P-19417

S6228

PARTY'S NAME	MA ENTERPRISES, NEW DELHI
PARTY'S DRAWING No.	AS PER SAMPLE & REQUIREMENT
ALLOY & TEMPER	6063 T6
DESCRIPTION	MISC. SECTION

DRAWING No.	SECTION No.
P-19417	-
S6228	S6228(ISSUE-3)

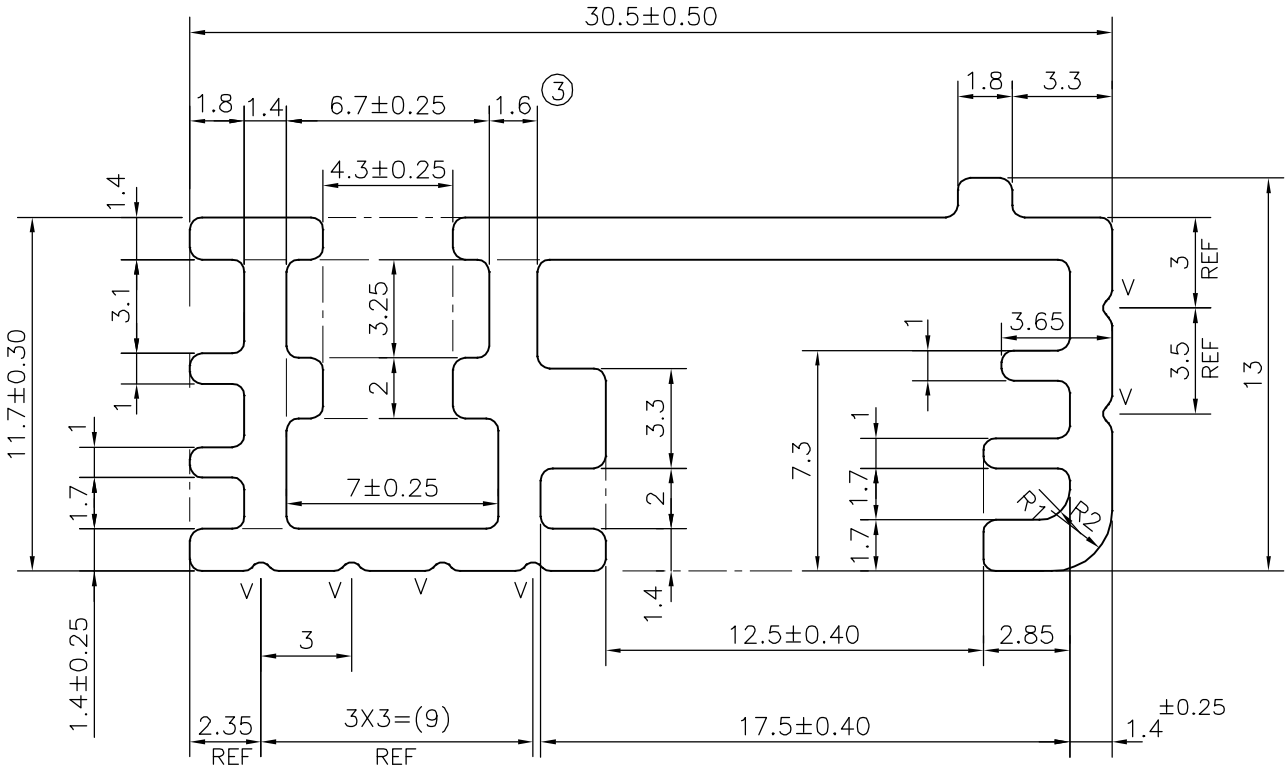
ISSUE-2

SIZE & SHAPE CHANGED

WEIGHT CHANGED FROM 0.390 TO 0.335 kg/m

ISSUE-3

THICKNESS CHANGED FROM 2mm TO 1.6mm.

WEIGHT CHANGED FROM 0.335 TO 0.331 kg/m
